Staff Report to the Municipal Planning Board April 20, 2021

Project Description

The 0.76 acre property is located south of W Church St., between S Lee Ave. and S Westmoreland Dr. in the Parramore/ Holden Neighborhood. The applicant is applying for a Master Plan to construct a 11,527 sq. ft. office building with ground floor retail and a 31 space surface parking lot.

Site Plan

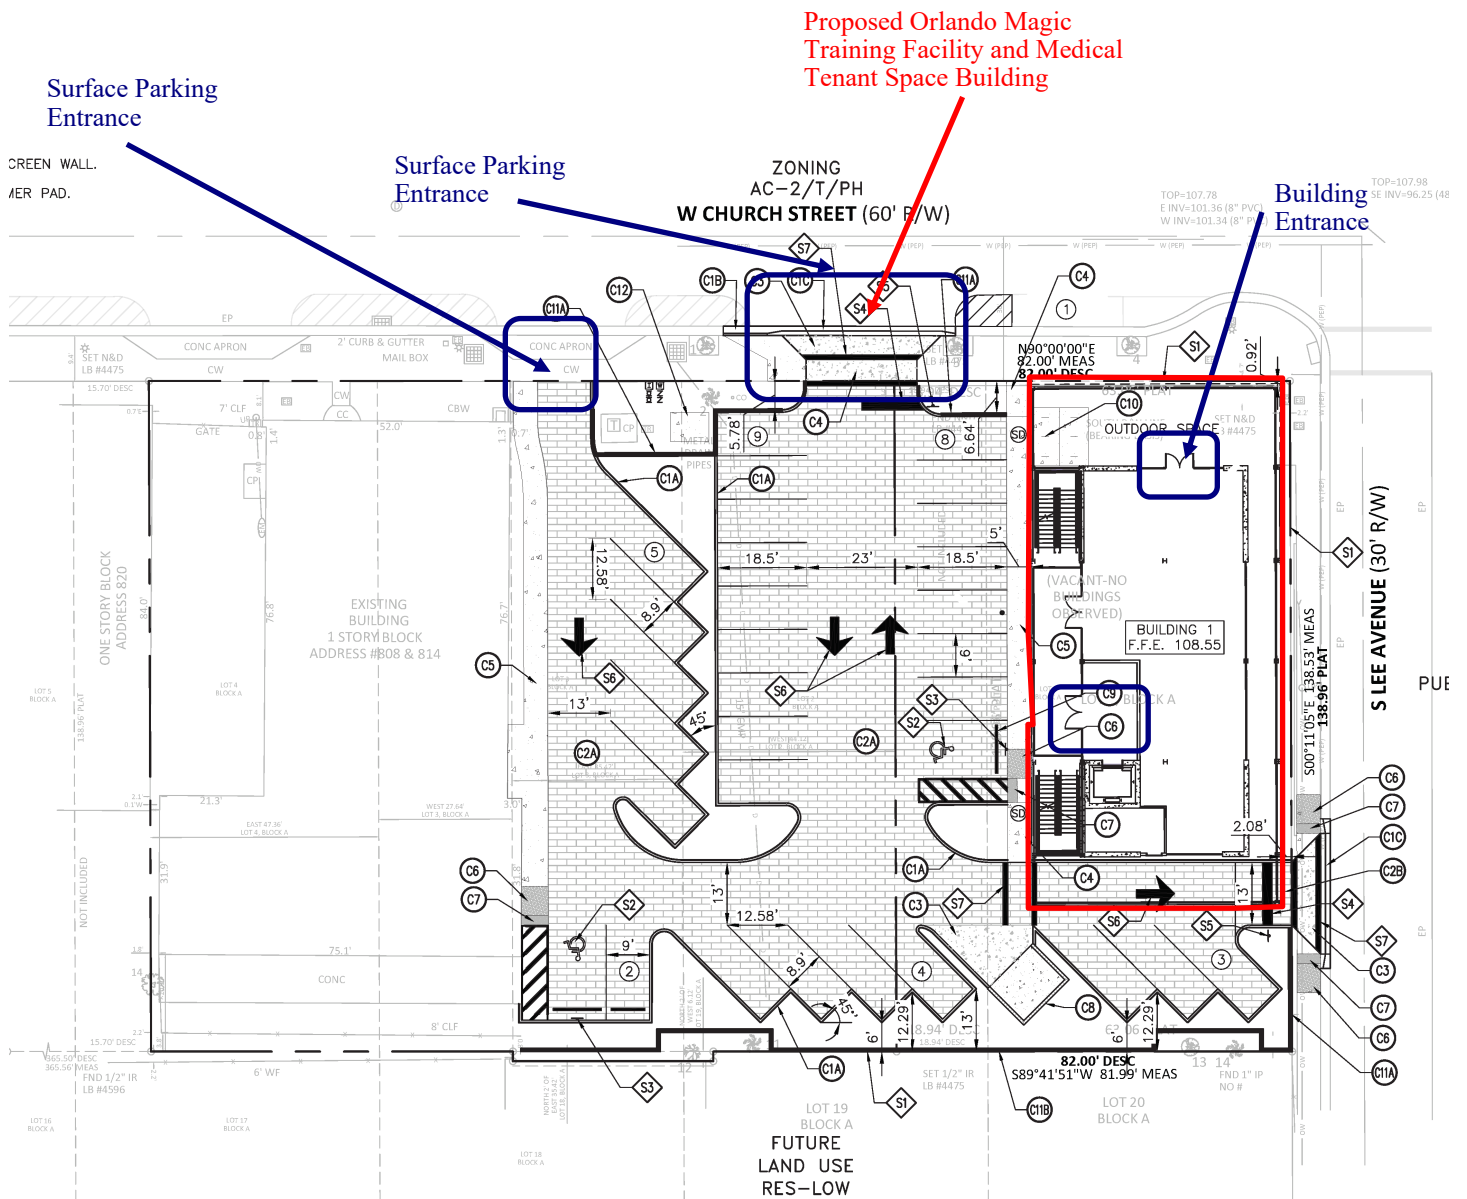
7. The sidewalk located at the western edge of the 13 ft. drive aisle must be widened to a minimum of 6 ft. in width.
8. The sidewalk located between the building and the eastern parking stalls must be widened to 7 ft. in width, 2 ft. of the parking space may overhang into this parking area. Alternatively, wheel stops may be used in the row of parking to prevent cars from overhanging the sidewalk.

9. Vehicle Parking. With the proposed 20% parking reduction, a total of 36 parking spaces must be provided on-site or through an off-site parking agreement in accordance with LDC Sec. 61.303.

14. Turning Radius: City of Orlando apparatus requires a turning radius dimension of 30 inside and 50 exterior and shall maintain the minimum 20ft. width. An auto-turn analysis is required for the radius turns indicated on the site plan. NFPA 1.18.2.3.5.3.1 and NFPA 1.18.2.3.5.3.2

Landscape Plan

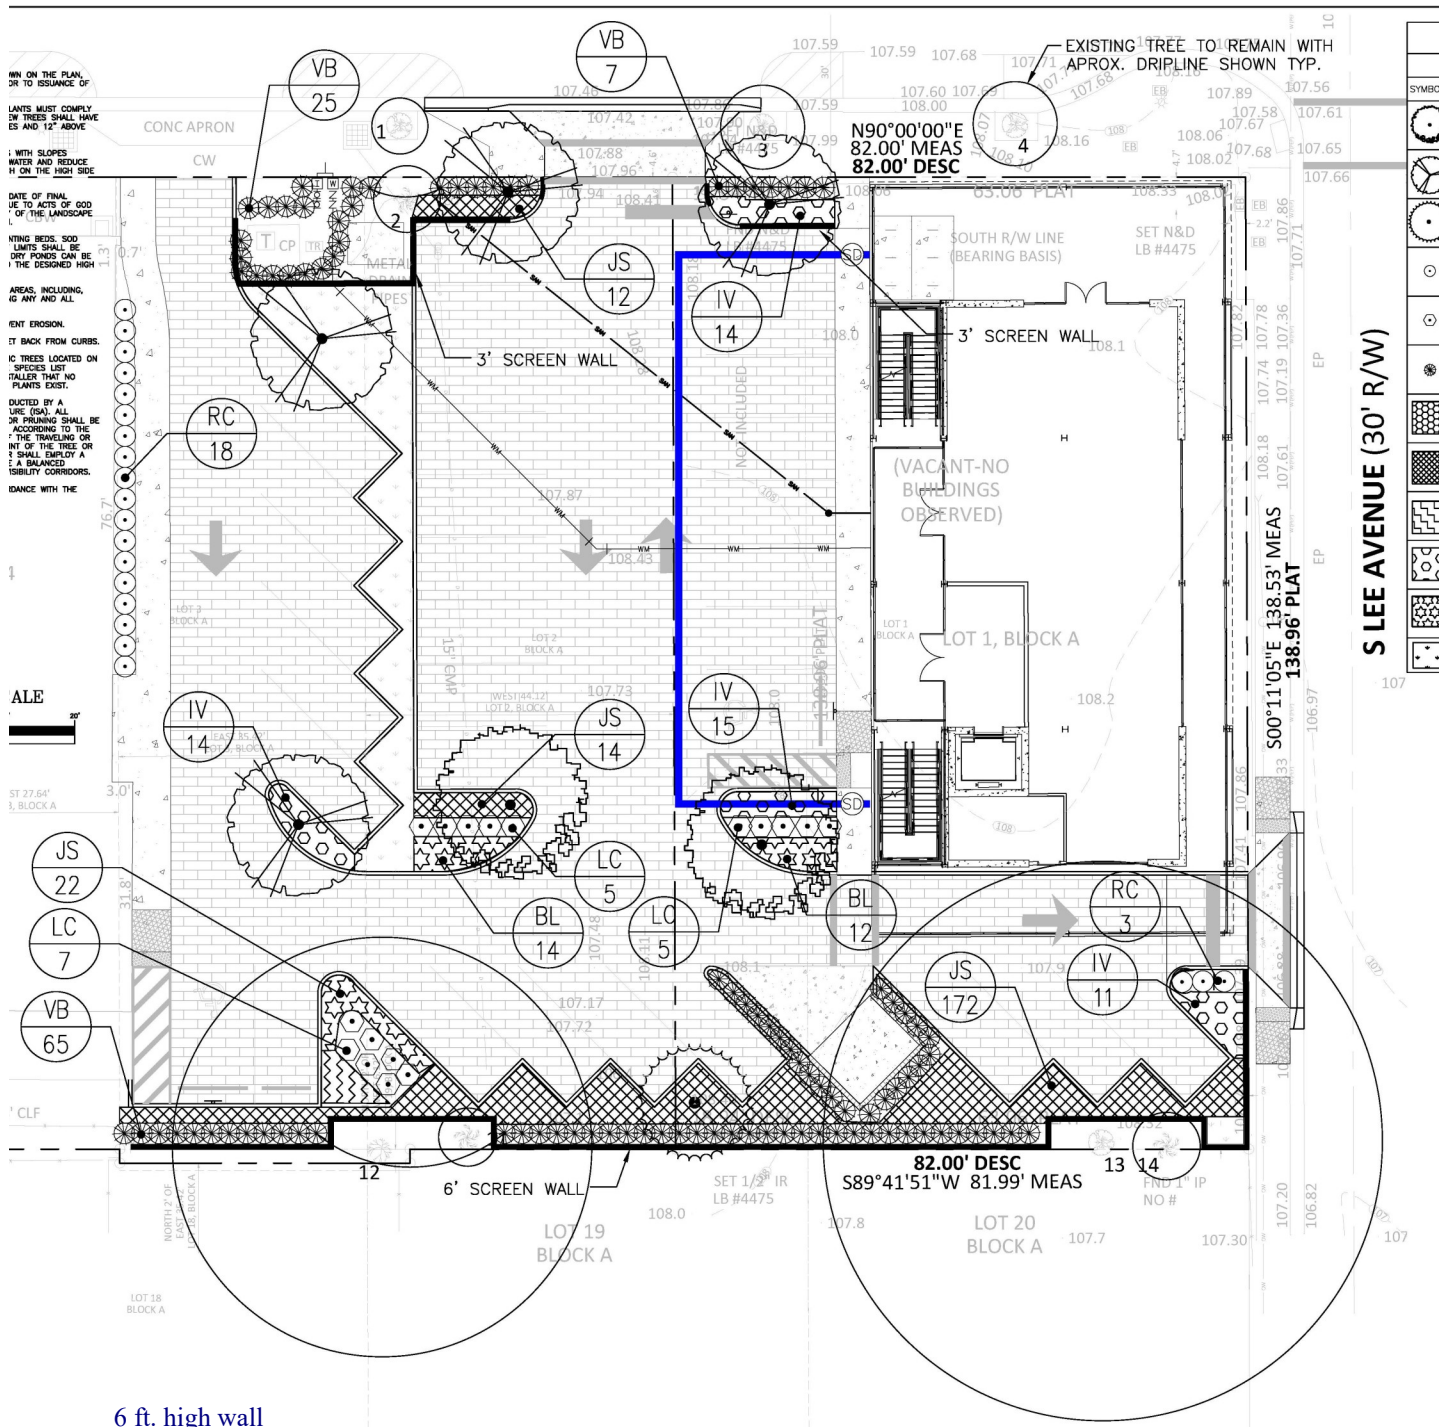
7. Impervious Surface Ratio [ISR]. The is limited to 0.90.
8. Vehicular Use Buffer. Min. 7.5' of landscape width, to include trees and hedge or wall, is required between vehicular use areas and the public rights-of-way. See parking lot landscape requirements of Chapter 61 of City Code.

10. Bufferyard B. Minimum of 8' width; 80% tree coverage; continuous 6' height wall' vegetative cover over remainder of bufferyard. Or minimum of 10' width; 80% tree coverages; 1 row of evergreen shrubs; vegetative cover over reminder of bufferyard.
